BASIC PERMIT PACKAGE
REVIEWED FOR CODE COMPLIANCE
WITH IRC 2015
KITSAP COUNTY BUILDING DEPARTMENT

a new model home for
Disney & Associates

Plan 2322

~ MAIN FLOOR PLAN

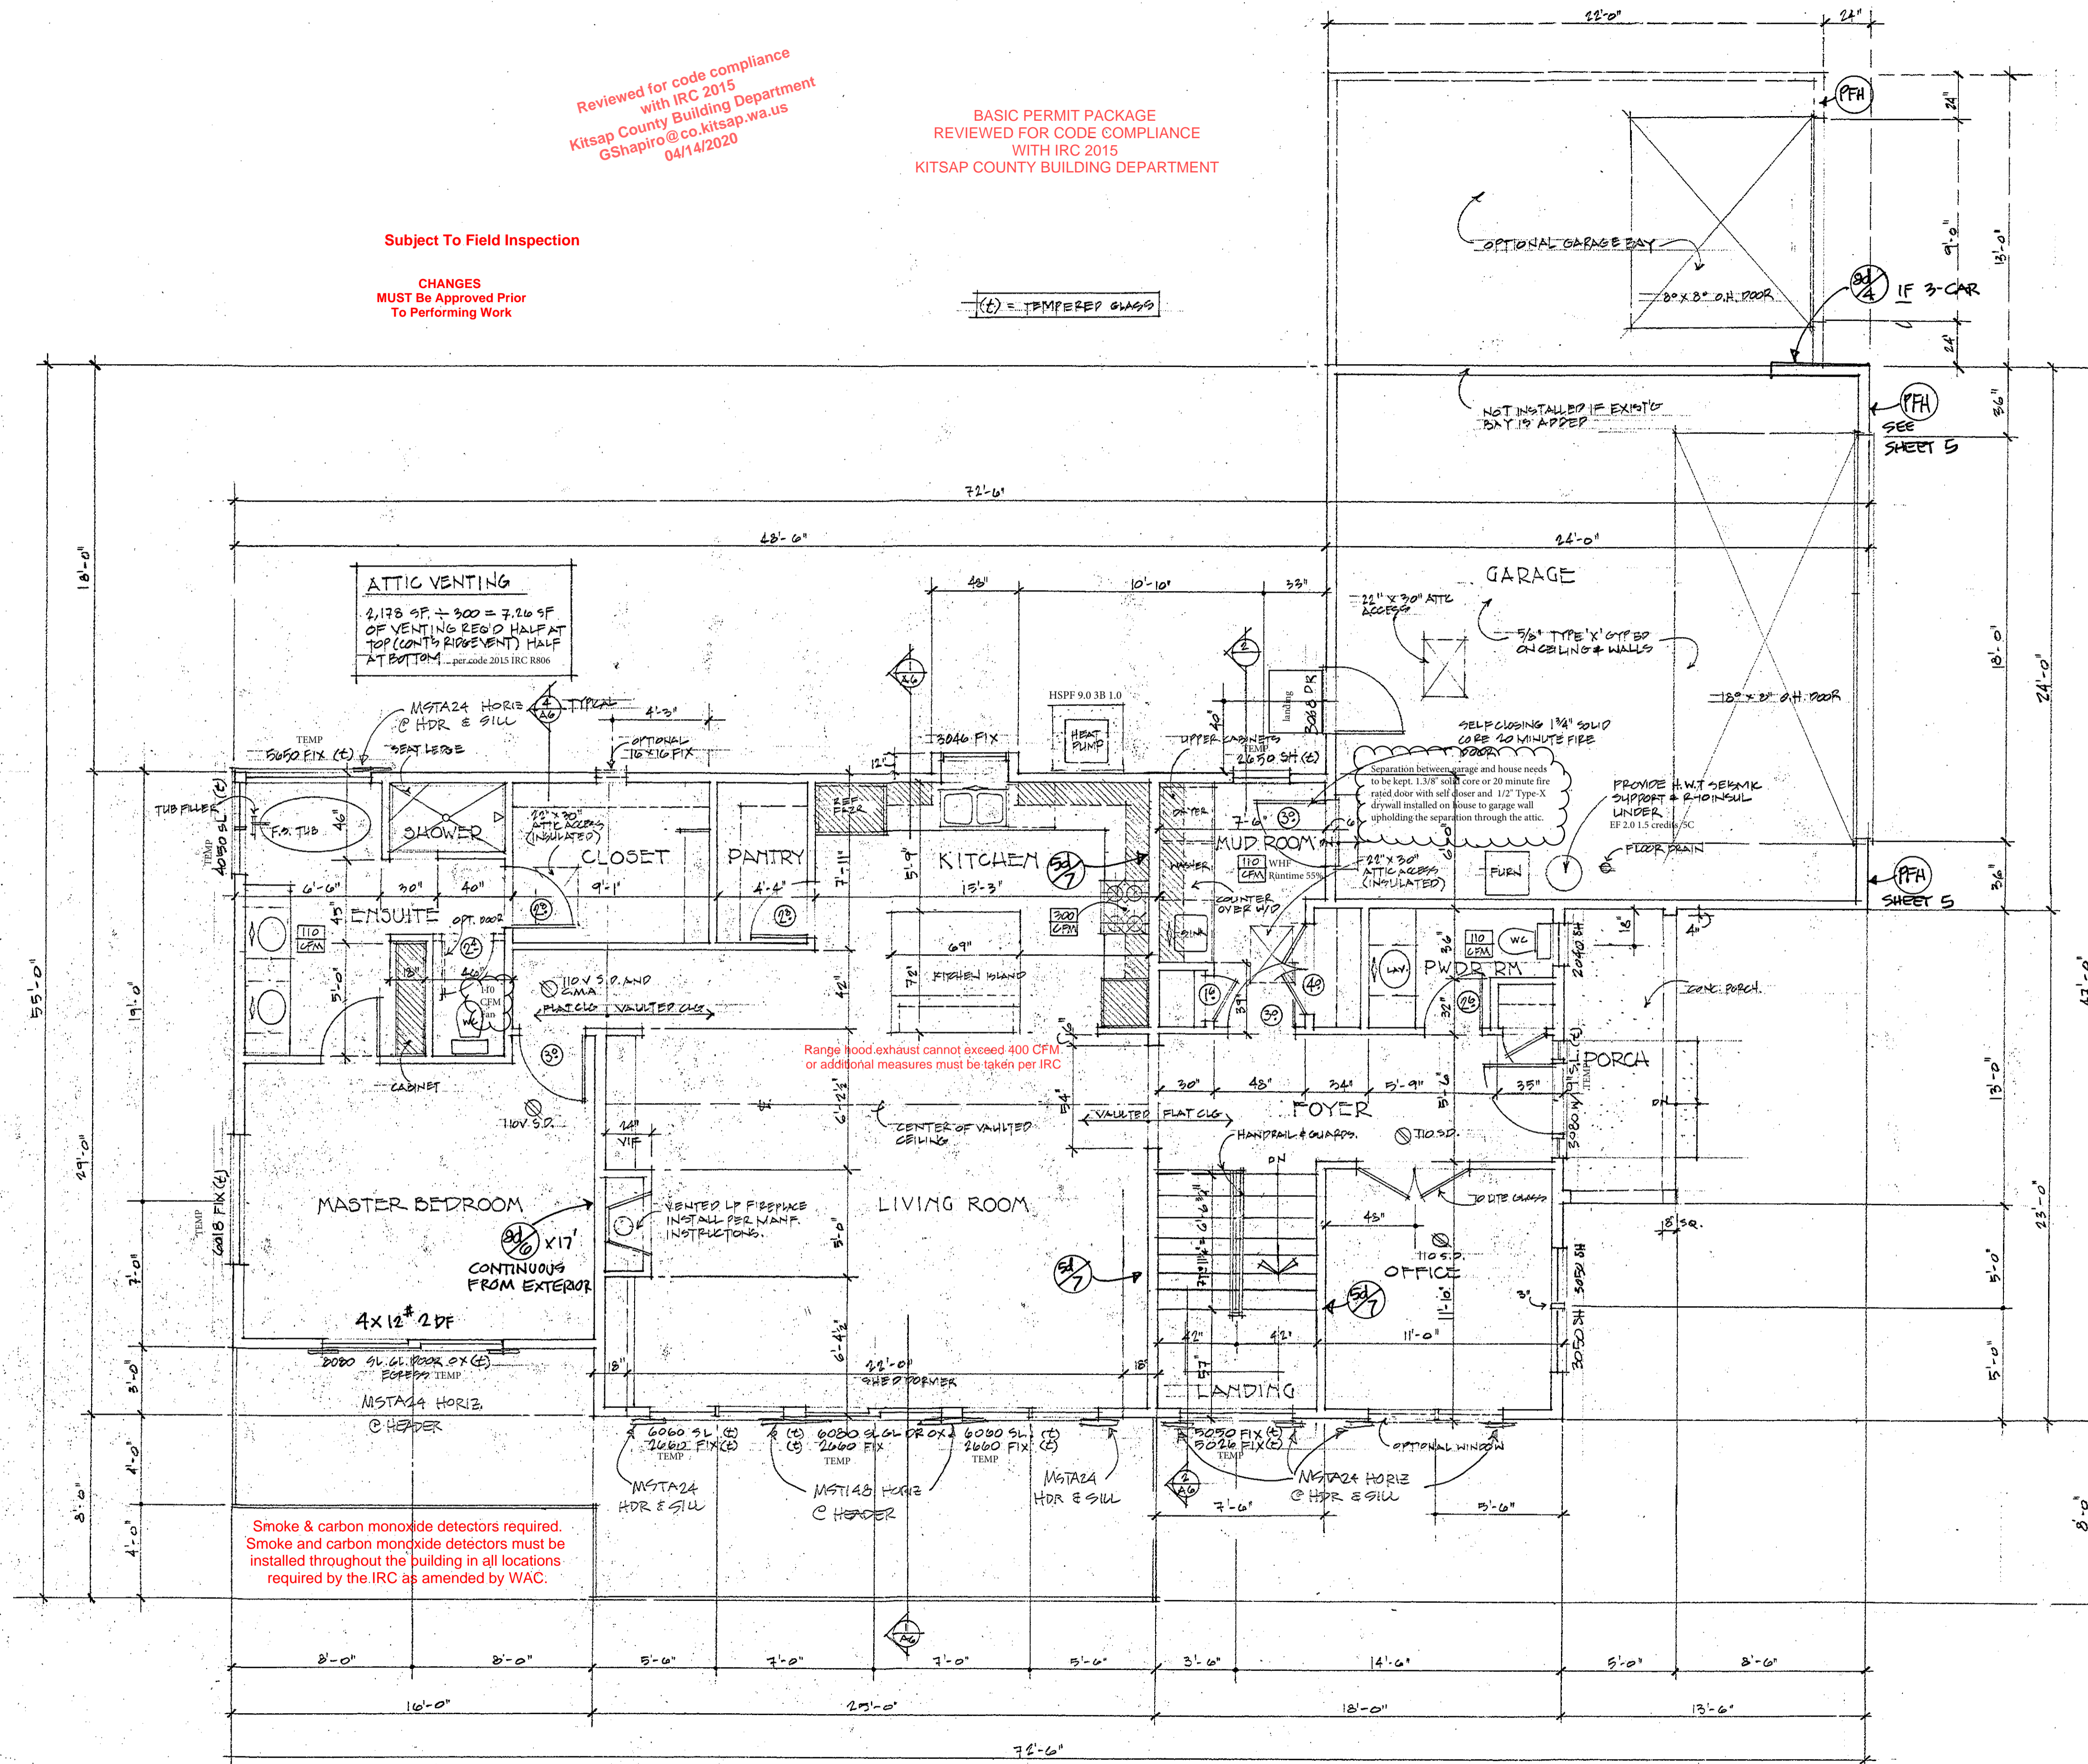
(E) = TEMPERED GLASS

A3

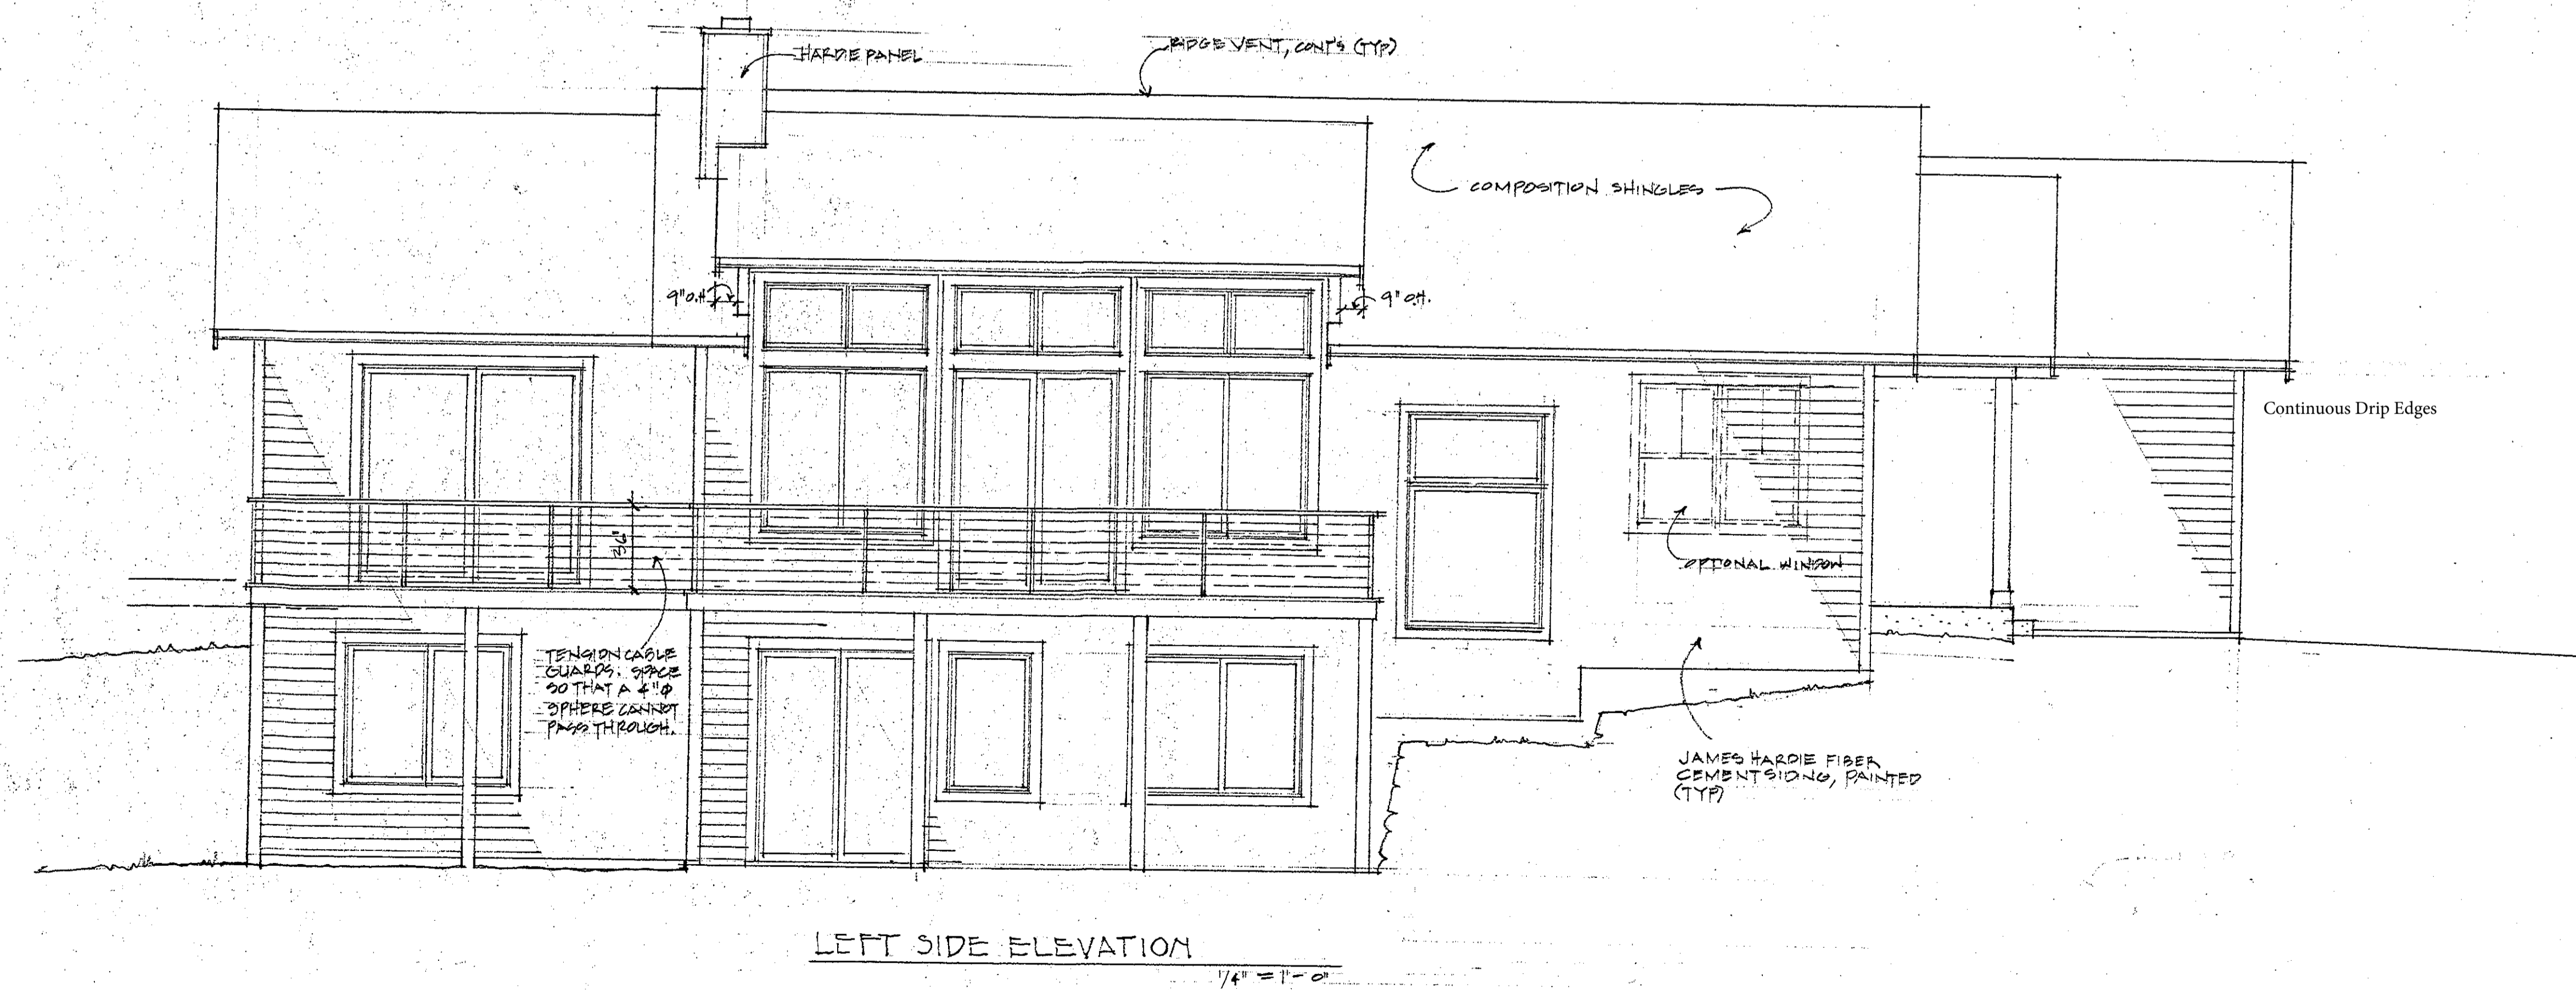
Gutters and downspouts are required.
All roof and yard drains shall be directed to splash blocks at a minimum,
or to an infiltration system if required. All surface drainage shall have a
minimum 2% grade away from the foundation.
